### Sony KDL-40R450A (1080p)

PRODUCT  
TRANSITION

### Sony KDL-40W600B (1080p)

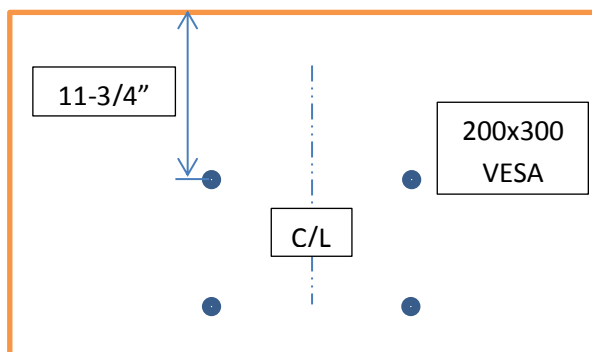
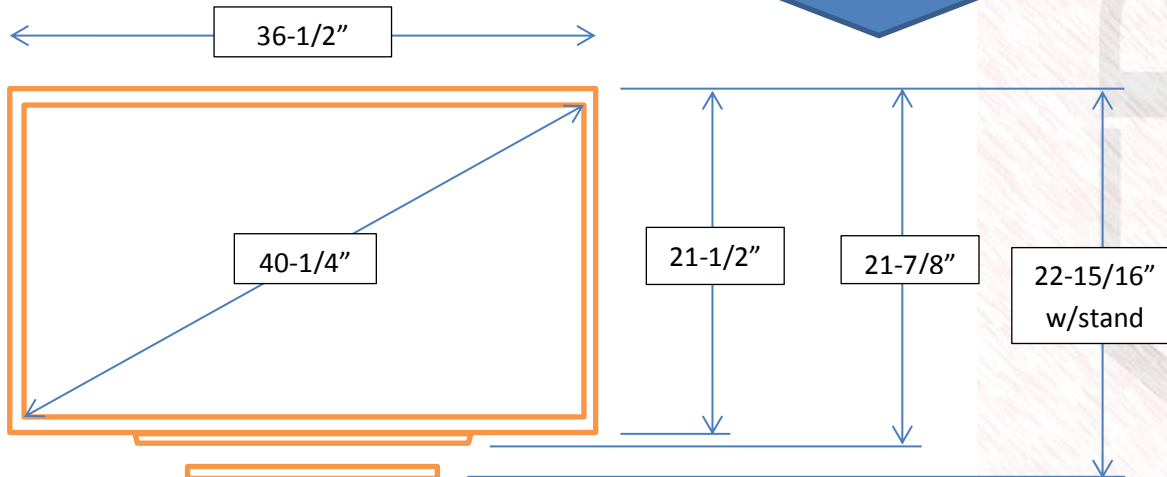
Depth -3" at VESA mount

3" overall

7-1/8" w/stand (stand 21-3/8" W)

Depth -3-1/2" at VESA mount

3-5/8" overall

6-3/8" w/stand (stand 21-5/8" W)

4 HDMI inputs vs. 2, 2 USB inputs vs. 1,  
LAN/WIFI added (SMART)
